## 2 SITE CHARACTERISTICS

### 2.0 North Anna 3 Site

This chapter of the U.S. Nuclear Regulatory Commission's (NRC's) safety evaluation report (SER) provides the NRC staff evaluation of the North Anna 3 Combined License (COL) Final Safety Analysis Report (FSAR) which addresses the geological, seismological, hydrological, and meteorological characteristics of the site and vicinity, in conjunction with present and projected population distributions and land use and site activities and controls.

**Figure 2.4.2-1. Site map with locations of drainage basins and primary hydraulic features of the drainage system flooding analysis from local intense precipitation (after North Anna 3 COL FSAR Figure 2.4-201)**

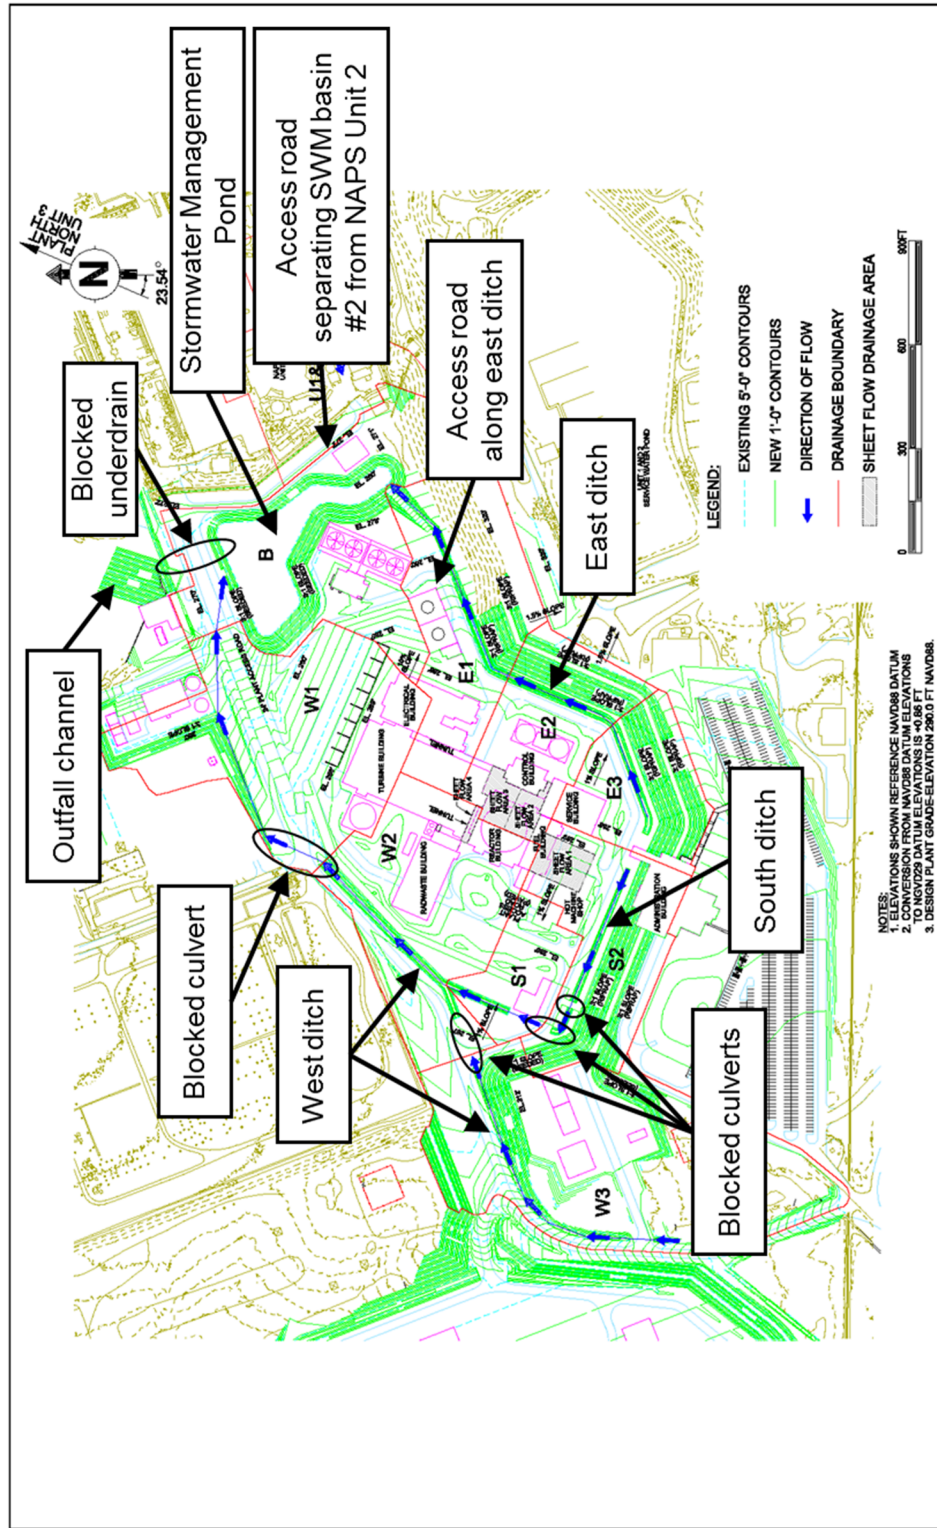
The site drainage plan consists of three drainage channels (labeled east ditch, south ditch, and west ditch in Figure 2.4.2-1), a stormwater management pond, and an outfall channel. Figure 2.4.2-1 also shows the layout of drainage basins used in the estimation of local intense

precipitation-generated runoff. For the analysis of local intense precipitation flooding, the culverts were assumed to be blocked where the ditches passed under the plant access roads. In the HEC-RAS model of the drainage system, the roads crossing the ditches were treated as broad-crested weirs. As noted in Figure 2.4.2-1, these weirs are located in the south and west ditches. The east ditch has no weirs. Figure 2.4.2-2 shows the layout of HEC-RAS cross sections with respect to the ditches, stormwater management pond, and outfall channel. Figure 2.4.2-2 also shows the locations of blocked culverts, which were simulated as inline weirs.

A drainage divide is located between the North Anna 3 stormwater management pond and the existing Unit 2 site at an elevation of 82.91 m (272.0 ft) NAVD88. As indicated in Figure 2.4.2-1, the stormwater management pond received flow from the east and west ditches. Discharge was routed from the stormwater management pond by overtopping the main access road, which was simulated in the HEC-RAS model as a broad-crested weir. The maximum water surface elevation computed by the COL applicant in the stormwater management pond was 82.84 m (271.8 ft) NAVD88 resulting in a freeboard of 0.06 m (0.2 ft). The COL applicant concluded that flows in North Anna 3 site would not affect the existing Units 1 and 2. Although the staff found references to Subbasin U1&2 in North Anna 3 COL FSAR Tables 2.4-201 and 2.4-202 (Table 2.4.2-2), the COL applicant did not adequately explain how Subbasin U1&2 derived flow from the existing Units 1 and 2 area. In RAI 02.04.02-10, the staff requested that the COL applicant provide additional details regarding how the rational method was applied to estimate peak discharges, particularly from Subbasin U1&2 (ML14345B075). The COL applicant's response dated January 19, 2015 (ADAMS Accession No. ML15022A199), and the staff's evaluation are described in the staff's technical evaluation section below in this SER.

In response to staff's RAI 02.04.02-10 through 02.04.02-15, the COL applicant proposed updating the North Anna 3 COL FSAR in a future revision (ADAMS Accession Nos. ML15022A199 and ML16229A451). The staff verified that the appropriate updates are incorporated into the FSAR, Revision 9, and, therefore Confirmatory Items 2.4.2-1 to 2.4.2-6 from the staff's advanced SER for North Anna 3 are resolved and closed.

Figure 2.4.2-2. Site map with locations of the inline control structures that correspond to blocked culverts (after North Anna 3 COL FSAR Figure 2.4-203)

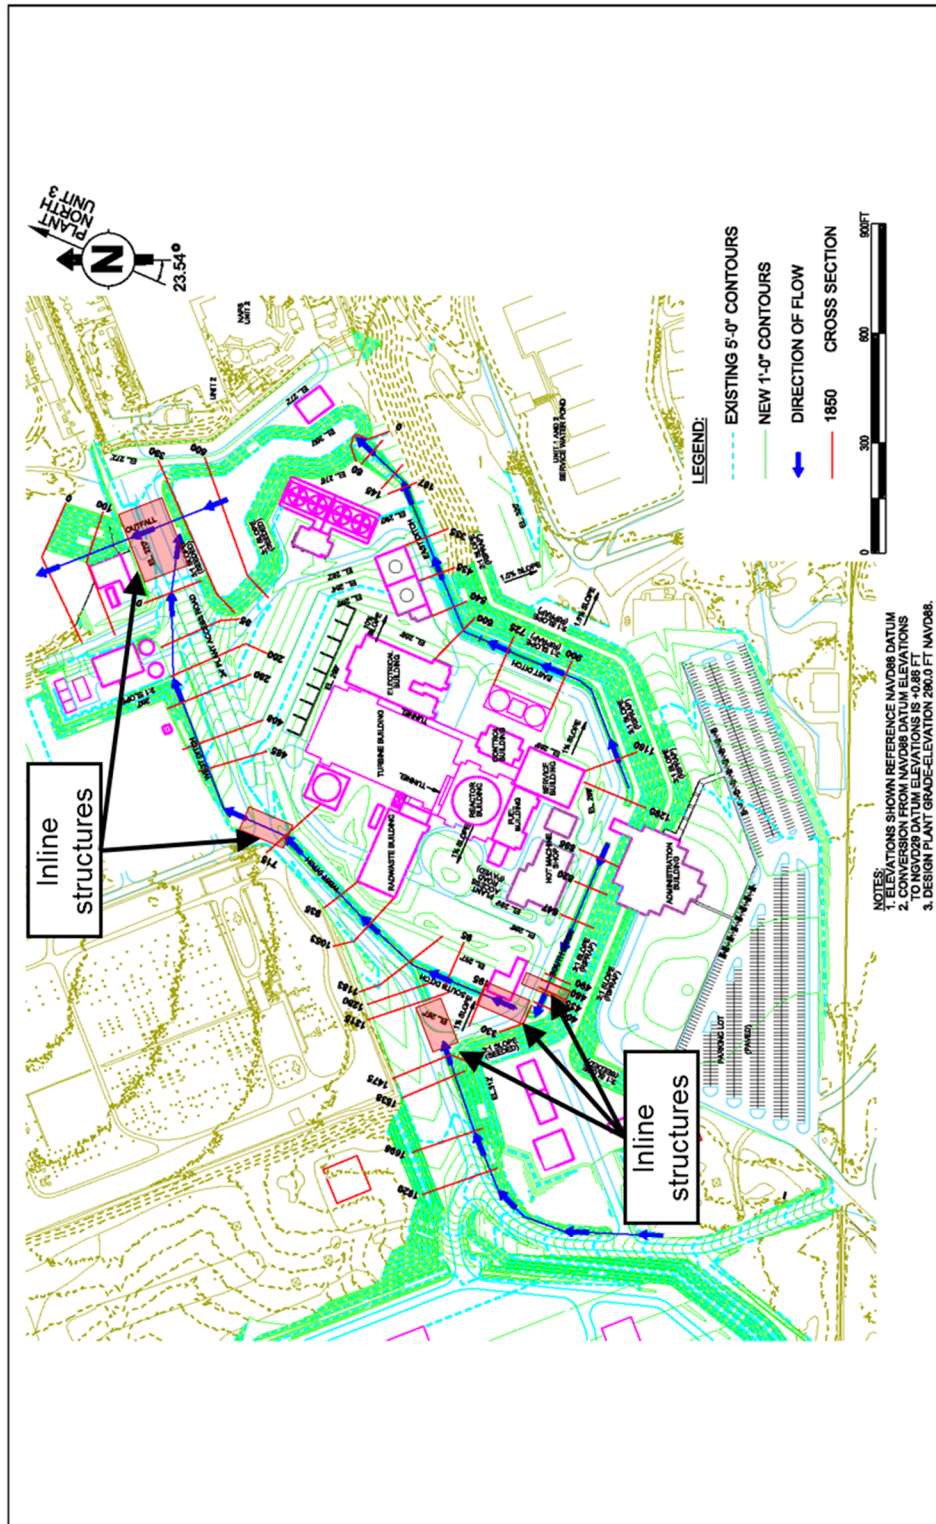
The COL applicant assumed that the roads crossing the west and south ditches and the outfall from the stormwater management pond were completely blocked and functioned as weirs during the flooding from local intense precipitation (Figures 2.4.2-1 and 2.4.2-2). As found in the COL applicant's HEC-RAS input files, inline weirs were designated as broad-crested weirs with discharge coefficients specified as either 2.6 or 2.4. Because the COL applicant did not provide a justification for choosing the lower of these two discharge coefficient values, in RAI 02.04.02-14, the staff requested that the COL applicant provide a discussion of the basis for selecting weir discharge coefficients. The COL applicant's response dated January 19, 2015 (ADAMS Accession No. ML15022A199), and the staff's evaluation are described in the staff's technical evaluation section below in this SER.

Figure 2.4.2-3. Site map with locations of supercritical flow and of hydraulic jumps from the applicant's HEC-RAS model and North Anna 3 COL FSAR Figure 2.4-221 (after North Anna 3 COL FSAR Figure 2.4-203)

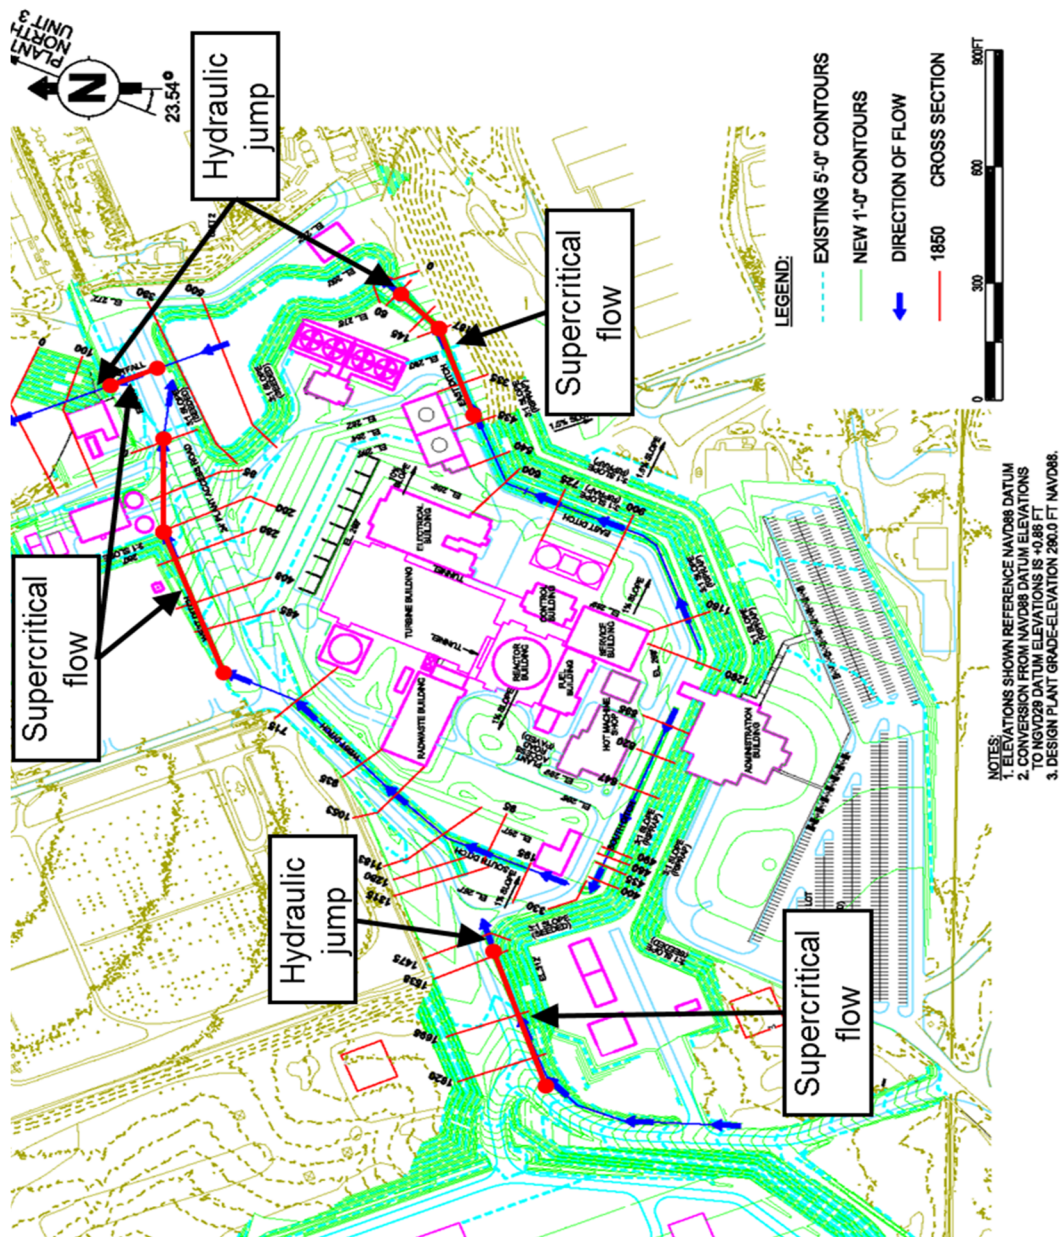
Based on the staff's examination of the COL applicant's HEC-RAS analysis results, supercritical flow was found to occur in the east and west ditches during flooding from local intense precipitation. In these locations, the water velocities ranged from 2.1 m/s (7.0 fps) to 4.5 m/s (14.7 fps) with Figure 2.4.2-3 showing the locations of supercritical flow based on the HEC-RAS analysis. In North Anna 3 COL FSAR Section 2.4.2.3, the COL applicant stated that:

Figure 2.4.2-4. HEC-RAS schematic of the channel geometry derived from input files provided by the COL applicant

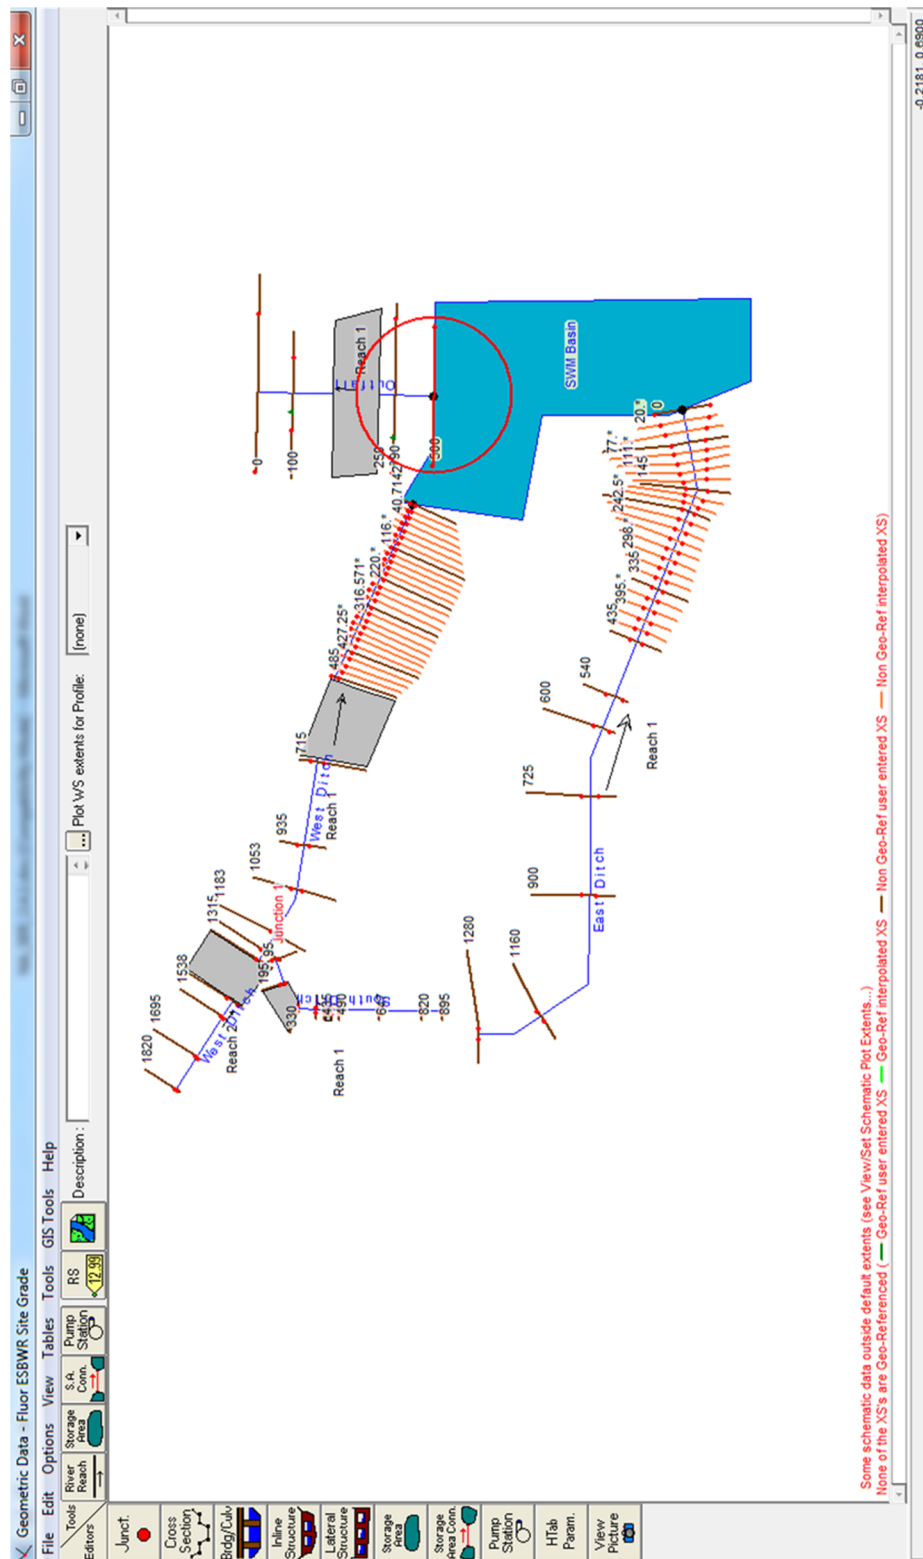
The staff noted that the applicant's HEC-RAS input file geometry was inconsistent with the connectivity of the west ditch for the storm water management pond. In RAI 02.04.02-12, the staff requested that the COL applicant explain the apparent disagreement between the HEC-RAS input files and North Anna 3 COL FSAR Figures 2.4.201 and 2.4.203 which illustrate the connection of the west ditch to the stormwater management pond. In response to RAI 02.04.02-12 (ADAMS Accession No. ML15022A199), the COL applicant stated that as the west ditch approaches the stormwater management pond, water will flow in three directions: a portion will flow north into an area adjacent to the intake channel, another portion will flow south into the stormwater management pond, and a third portion will continue flowing along the west ditch towards the stormwater management pond outlet and into Lake Anna. The COL applicant chose to direct all flow from the west ditch into the stormwater management pond because the calculated water surface elevation would then be conservatively higher in Subbasin B. The COL applicant proposed updating North Anna 3 COL FSAR Figures 2.4-201 and 2.4-203 to correctly depict the discharge from the west ditch into the stormwater management pond, consistent with the HEC-RAS model setup. The staff determined that the COL applicant's response was adequate and verified that the appropriate updates to Figures 2.4-201 and 2.4-203 are incorporated into the FSAR, Revision 9, and, therefore, Confirmatory Item 2.4.2-3 from the staff's advanced SER for North Anna 3 is resolved and closed.

**Figure 2.4.122-1. NAPS Unit 3 groundwater head observations on 5/30/2007 as a function of ground surface elevation at the well**

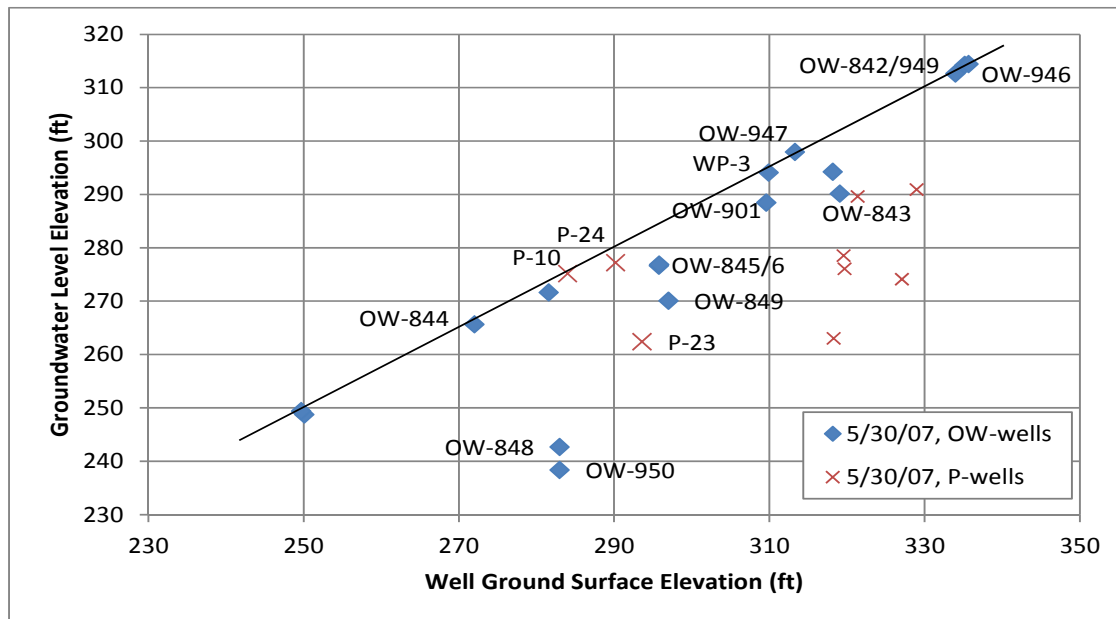
While no observations fall significantly above the envelope line in Figure 2.4.12-1, a number of observations fall significantly below the line. The staff examined the current site topography, as shown on FSAR Figure 2.4-206, and determined that the wells with observations below the line in Figure 2.4.12-1 tended to be located above and near a significant topographic slope. For example, OW-848 and OW-950 are on the bluff above the proposed North Anna 3 intake bay, and OW-849 and OW-843 are above the cut-slope for the switch yard. In contrast, the observations that lie close to the line in Figure 2.4.12-1 tended to be in areas of relatively flat topography, or near the bottom of topographic slopes. For example, OW-844 lies just below the cut-slope down to the Unit 1/2 operations level.

The COL applicant's pre-construction model, calibrated using the May 30, 2007 groundwater observations, resulted in groundwater heads at several observation wells that were above the envelope line shown in Figure 2.4.12-1. The greatest deviations were at wells OW-945, a relatively low-lying area where the model produced flooded conditions, and OW-844, located at the bottom of a cut-slope. The deviation at OW-844 was about 1.22 m (4 ft). Based on the observations shown in Figure 2.4.12-1, the staff concluded that groundwater head measured in a well located at a surface elevation of 88.39 m (290 ft) (the North Anna 3 design plant grade) would be unlikely to exceed 85.34 m (280 ft). The COL applicant's post-construction model predicted heads about 1.22 m (4 ft) greater than this in the power block area: 86.53 m (283.9 ft) at the Ancillary Diesel Building, located near the cut-slope down to the power block. The staff concluded that the COL applicant's groundwater model will tend to over-estimate groundwater heads below a cut-slope such as that planned around the North Anna 3 power block area.

**Figure 2.5.1-3. Recent geologic map (Burton et al. [2014]) and aftershocks (McNamara et al. 2014) in the 2011 Mineral, VA, earthquake epicentral area within 25 miles of the NAPS site (from FSAR Figure 2.5.1-210C, Rev. 9)**

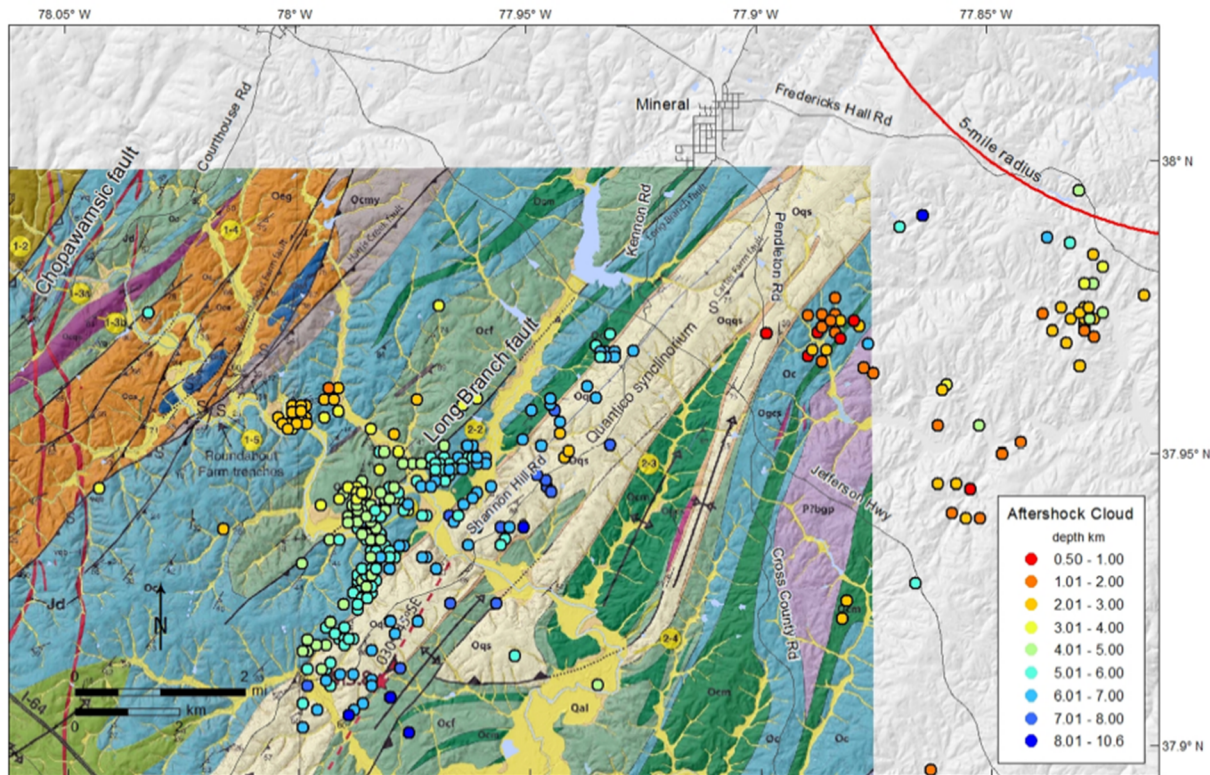
The staff notes that the NW facing topographic scarp is more or less coincident with the newly identified Harris Creek and Roundabout Farm faults and the surface projection of the Mineral earthquake rupture plane. The staff also note that the maps and figures (RAI 2.05.01-4b response, Figures 5A, 5B, and 6) provided for explaining the erosion susceptibility differences did not clearly support the observations stated in the text and that other interpretations were possible. Therefore, in a supplemental RAI 02.05.01-8 dated August 1, 2014 (ADAMS Accession No. ML14283A557), the staff asked the COL applicant to provide clarification and further justification that this is not a neotectonic signature in the landscape.

In a September 30, 2014, response to RAI 02.05.01-8a (ADAMS Accession No. ML14274A303), the COL applicant stated that the Harris Creek fault is largely coincident with the northwest-facing topographic scarp along approximately 10 km of the fault's mapped extent. The COL applicant provided several new figures (RAI response 02.05.01-8a, Figure 1B, 2A, 2B, 3A, and 3B) that illustrate the expression and extent of the topographic scarp and the geologic traces of the Harris Creek fault and Roundabout Farm faults. The staff observes, in the new figures, that the Harris Creek fault places Ellisville pluton granodiorite alongside Chopawamsic Formation for most of its extent and that the Harris Creek fault extends beyond or bifurcates from the topographic scarp to the SW and to the NE along the fault trace. There is a notable difference in erosion resistance between the granodiorite and the Chopawamsic formation lithology. The neck region of the Ellisville pluton is highly foliated (Burton et al., 2012) and susceptible to weathering and erosion whereas the Chopawamsic Formation, which includes mylonite, metafelsite, quartzite and schist, is more resistant to erosion. The Chopawamsic quartzite and schist (Ocqs map unit, Figure 2.5.1-3) is a relatively resistant unit within the Chopawamsic Formation and forms a series of linear ridges and topographic in the epicentral area. The COL applicant pointed out that the lineament, as characterized over most of its length, does not extend beyond Beaver Creek. The alignments of short, discontinuous and subtle landforms (i.e., ridges, spurs, small drainages) northeast of Beaver Creek do not match the continuity and prominence of the topographic scarp to the SW and are not coincident with the mapped trace of the Harris Creek fault. The staff notes that this difference is illustrated in RAI 02.05.01-8 dated August 1, 2014 (ADAMS accession No. ML14283A557), Figures 3A and 3B.
